HAM-VINE STREET NS

General Comment:

Given the geometric issues discussed on 9/4/24, between ORDC, D8, M&H, and Woolpert, the Stage 2 plans will need to be re-submitted showing the revised roadway design, accommodating the proposed truck turning arrangements, proposed by Woolpert.

TITLE SHEET

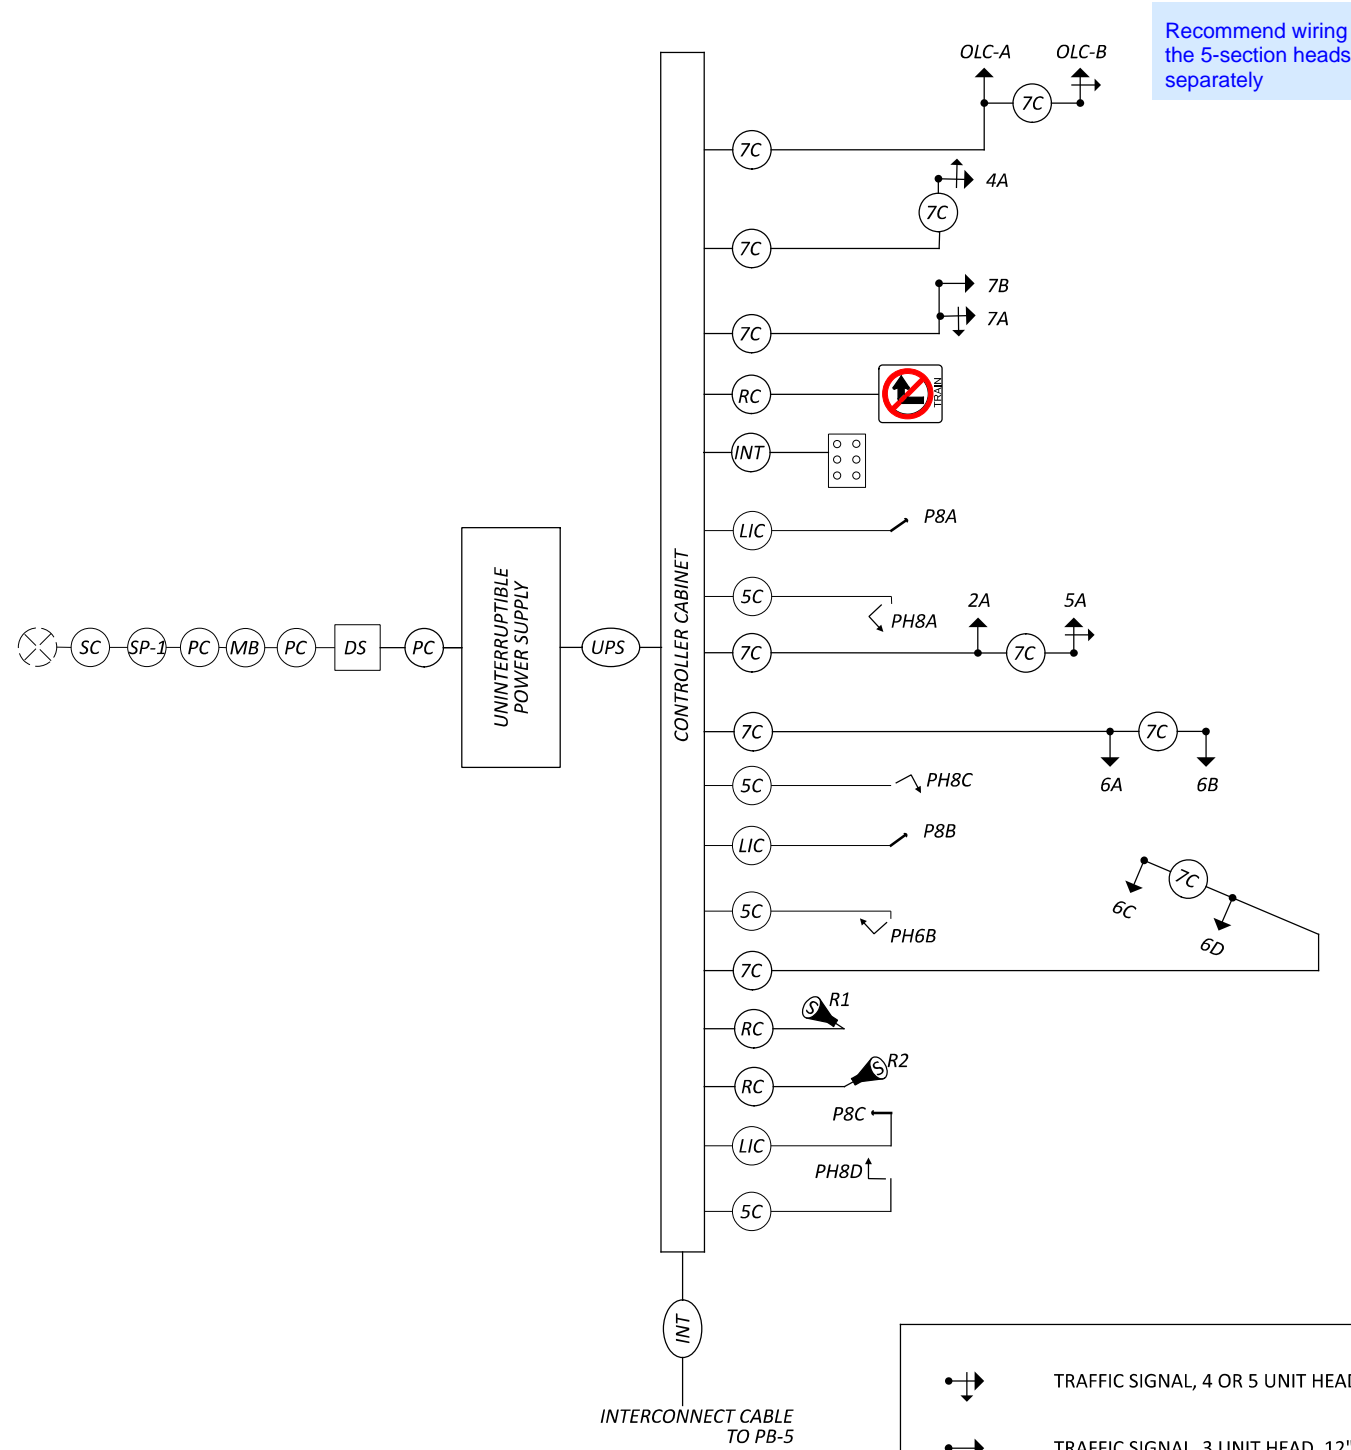
Are these notes applicable?

Info missing

service on this pole
